Floor Plan

PROJECT: IDEA PROJECT 2017

North Elevation

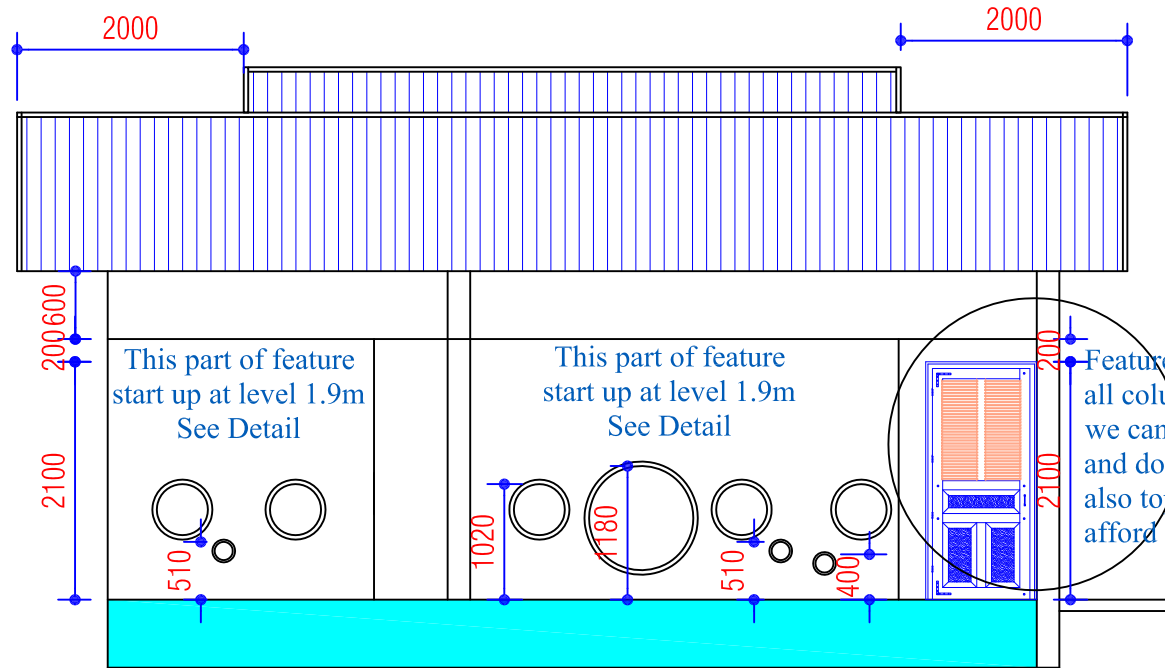
Feature at front should be changed because all columns need to be alignment we can not move column and do the decorative brick wall also top space is only 200mm so can not afford for decorative wall
